UNITED STATES PATENT AND TRADEMARK OFFICE

APPLICATION NO.	FILING DATE	FIRST NAMED INVENTOR	ATTORNEY DOCKET NO.	CONFIRMATION NO.
10/695,144	10/28/2003	Peter Van De Witte	NL 000326A	6435

Office Action Summary

FIG.1

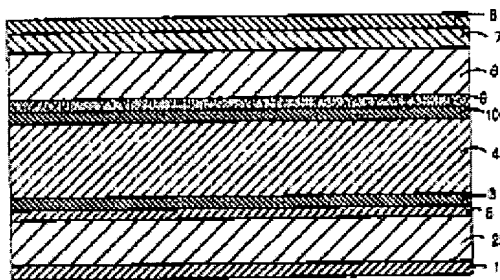
6. Kim discloses (col. 2, lines 64-67; col. 3, lines 1-8, 19-38) and shows in Fig. 1, a reflective active matrix liquid crystal display device comprising a liquid crystal layer (4) dispersed between an active (2) and a passive substrate (6) plate,

the active substrate plate (2) being present on the side opposite the viewing side and comprising a plurality of optically transparent pixel electrodes (3) and a plurality of active switching elements (not shown) for controlling the voltage supplied to the pixel electrodes,

the switching elements being spatially separated from, positioned subjacent, and electrically connected to the plurality of pixel electrodes (not shown) (col. 3, lines 31-38),

wherein the spaces separating the switching elements and the pixel electrodes is filled with an electrically insulating color selection layer (5) which selectively reflects light of particular wavelengths and renders the switching elements invisible to the light reflected.

Accordingly, claim 18 is anticipated.
